AGENDA SECTION: PUBLIC HEARINGS	ORIGINATING DEPT: PLANNING	ITEM NO. E-2
ITEM DESCRIPTION: General Development Plan #208 by the Williams Family Partnership, to be known as Williams Industrial Park. The applicant is proposing to develop approximately 38.70 acres with mixed commercial-industrial uses. A Zoning District Amendment is being considered concurrent with this application. The property is located east of the Shopko and Menards south stores and 28 th St. SE, and is north of TH 52.		PREPARED BY: Mitzi A. Baker, Senior Planner
<p>June 10, 2003</p> <p><u>City Planning and Zoning Commission Recommendation:</u></p> <p>The Planning and Zoning Commission held a public hearing on this item on May 28, 2003.</p> <p>Mr. Burke moved to recommend approval of General Development Plan #208 by the Williams Family Partnership, with the staff-recommended findings and conditions. Ms. Peterson seconded the motion. The motion carried 7-2. The commission recommended the following conditions/modifications:</p> <ol style="list-style-type: none"><i>This property shall be platted prior to development. Prior to Final Plat application, the applicant shall execute a Development Agreement with the City tha

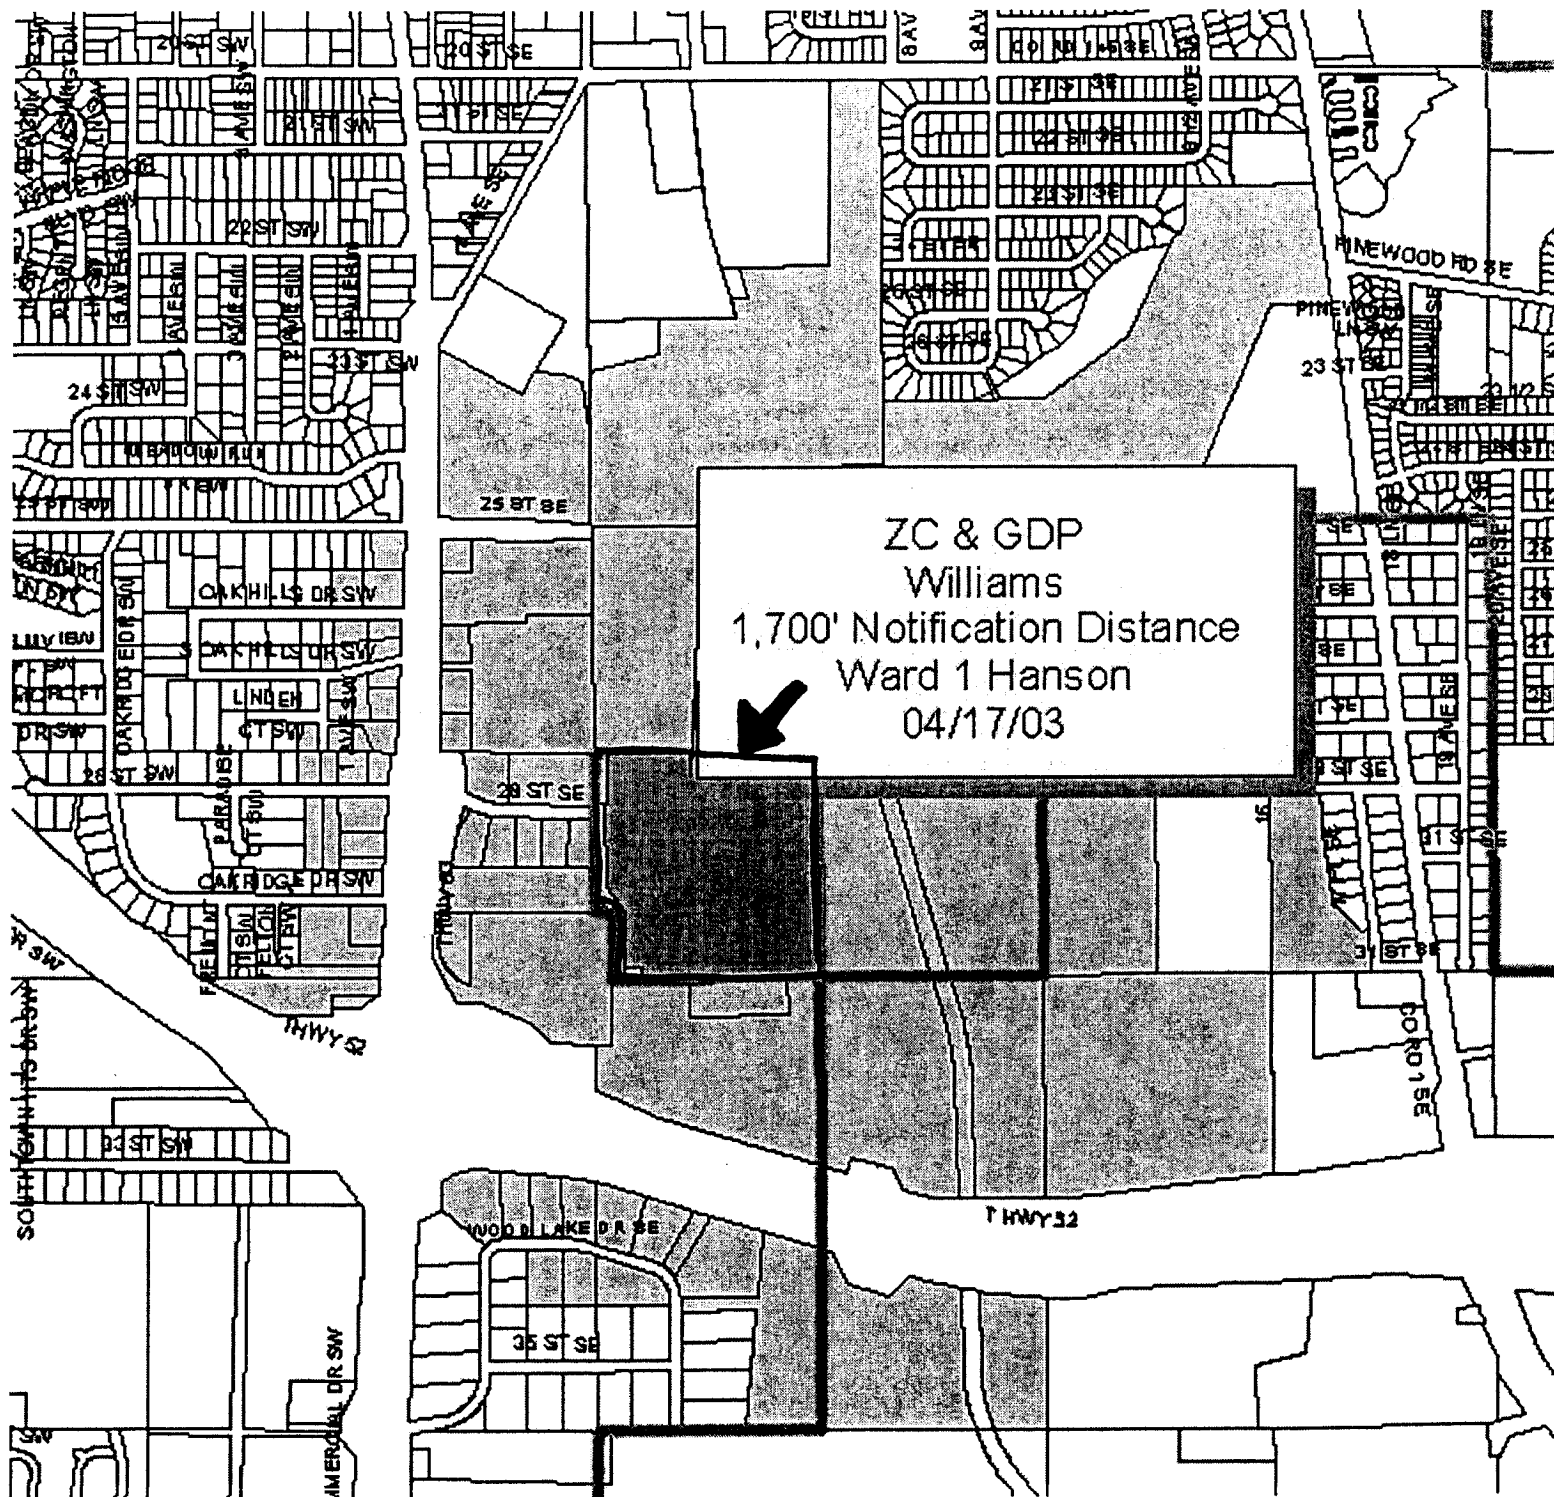
2. The proposed centerline radius of the 28th St SE realignment does not meet the radius previously discussed with the applicant's consulting engineer (Yaggy Colby). The GDP plan should be revised to accommodate a 250 ft centerline radius.

3. Dedication of a 50 foot wide public utility easement is required for maintenance and future replacement of the existing trunkline sanitary sewer. The easement area shall not contain wetlands that would need to be mitigated by the City to perform utility work within the required easement area.

2. Stormwater Management must be provided for this property. Any stormwater storage loss must be mitigated.
3. The proposed centerline radius of the 28th St./30th Ave. SE re-alignment shall be revised to accommodate a 250 foot centerline radius. This modification must be incorporated on a future Plat application.

GENERAL DEVELOPMENT PLAN # 208

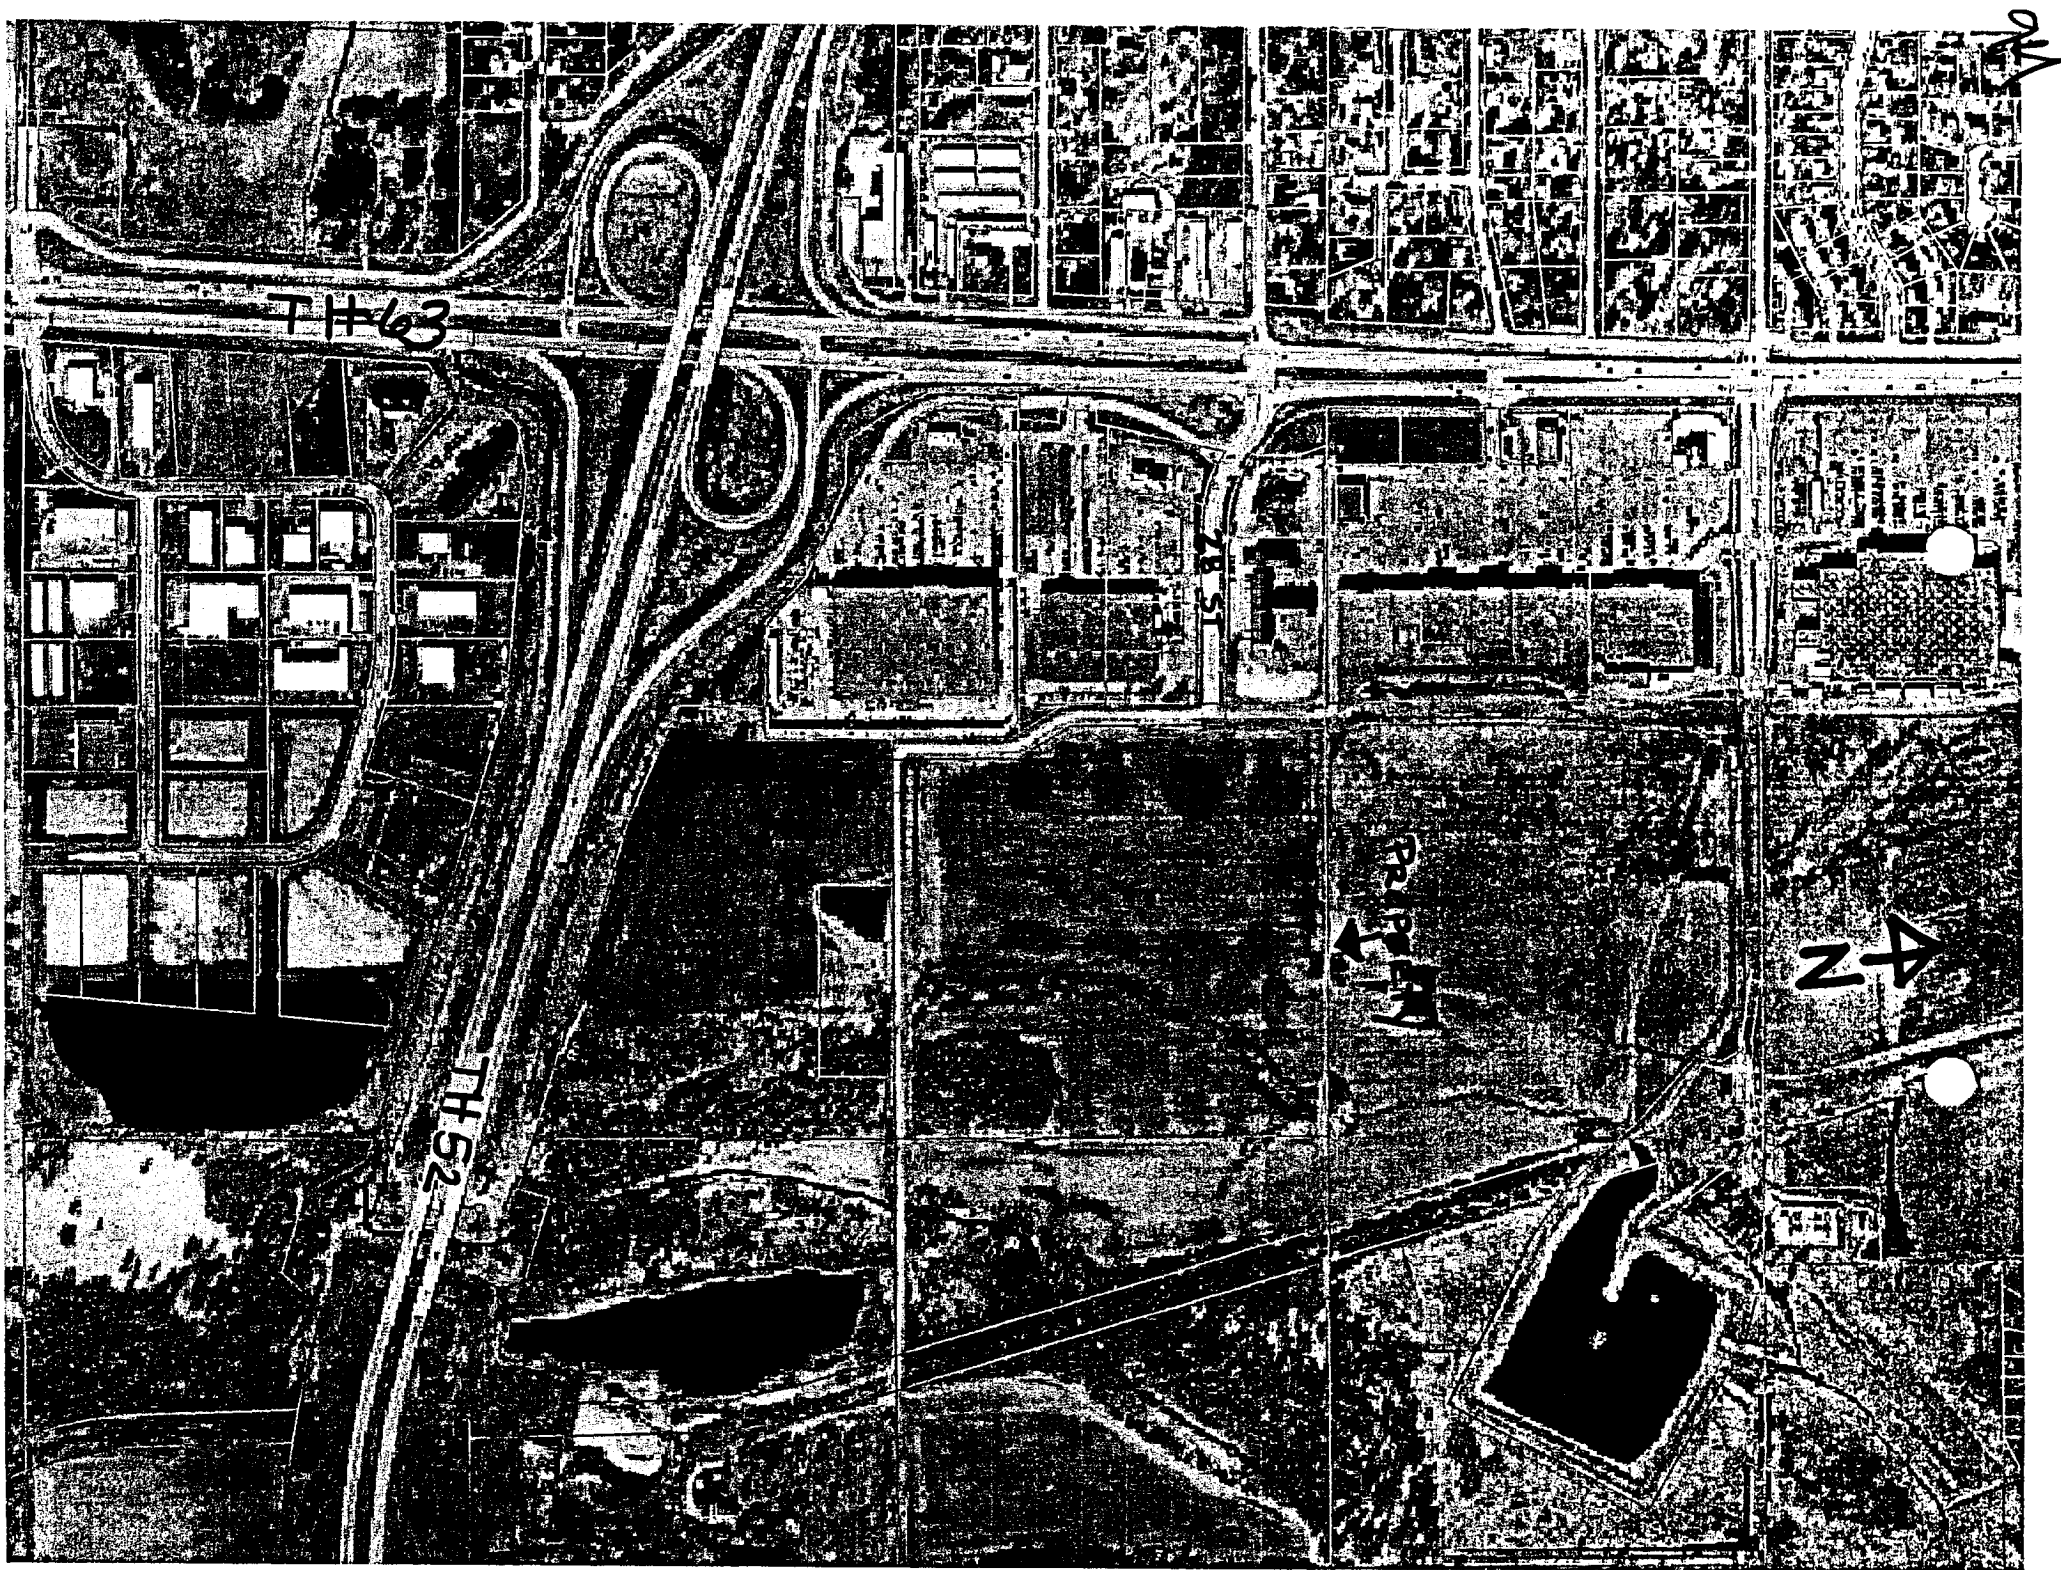
1. The roadway with a north / south alignment will need to be given a designation.

RECOMMENDATION: Designation for the roadway connecting 28 Street SE and 30 Street SE should be **3 AVENUE SE**.
